# FJ CRUISER

## OUTLINE OF NEW FEATURES

The following changes have been made for the 2008 model year.

### 6. Tire Pressure Warning System

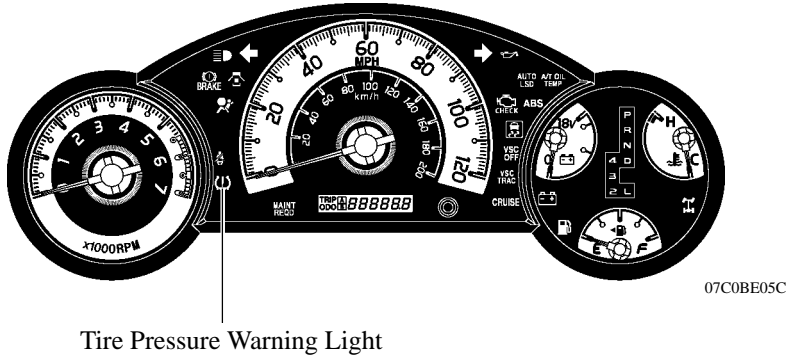
Tire pressure warning system has been provided on all models as standard equipment. For details, see page 8.

### 8. Combination Meter

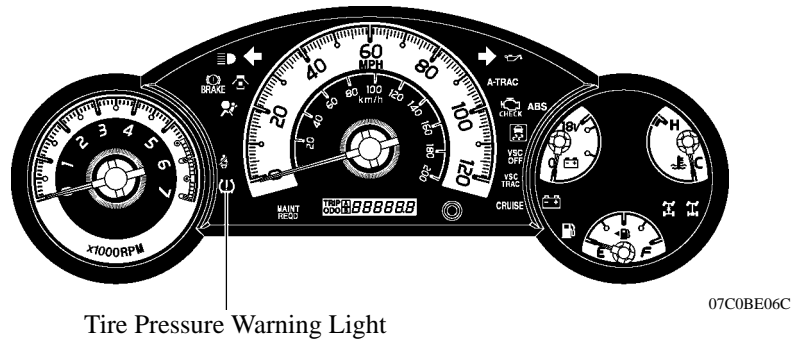
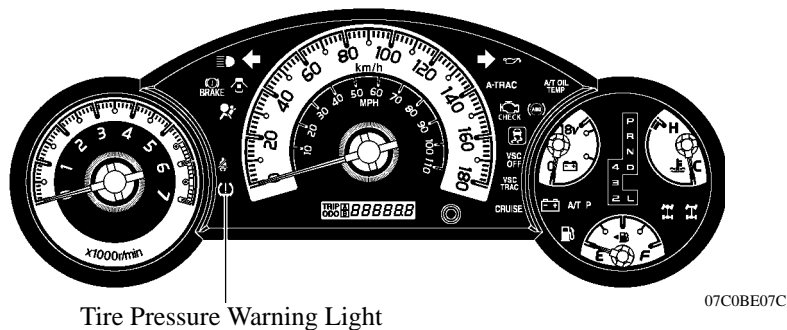
- The slip indicator light has been redesigned to improve visibility.
- A tire pressure warning light has been added, following the addition of the tire pressure warning system.
